Service Bulletin 491

Affected Models Street Triple and Street Triple R - All Models without ABS

Subject Brake Hose Clip

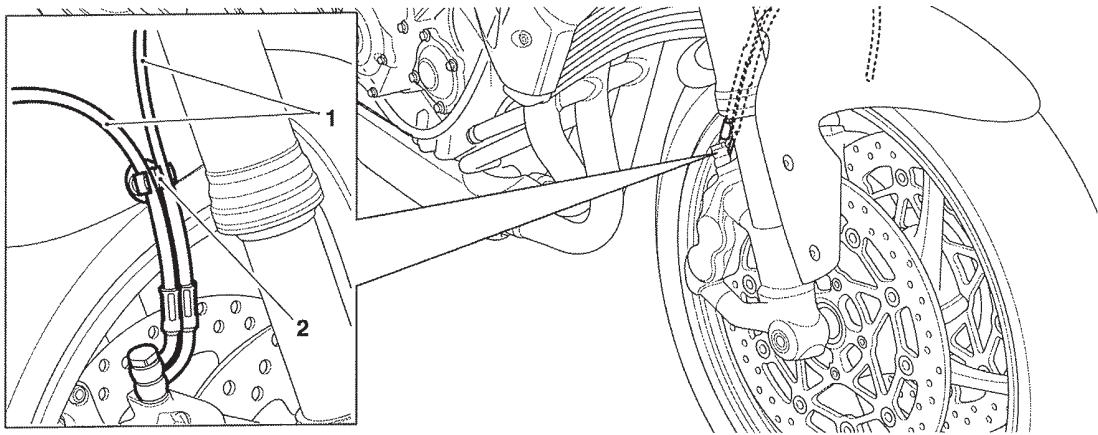
1. Detach the two brake hoses from their retaining clip on the right-hand side of the front mudguard.
2. Carefully remove the clip and retain it as described in the Genuine Parts Return Instructions on page 2.

3. Check the mudguard for damage that may have been caused by the front brake hoses.
4. **For lacquered finished mudguards only:** If the paintwork shows signs of scuffing, due to the brake hoses, apply a preparatory paint polish to the affected area using a soft cloth and work out the scuffing. If the marks can not be removed replace the mudguard and retain it as described in the Genuine Parts Return Instructions on page 2.
5. **For matt finished mudguards only:** If the paintwork shows signs of scuffing, replace the mudguard and retain it as described in the Genuine Parts Return Instructions on page 2.
6. Fit the new clip and secure the two brake hoses to it.
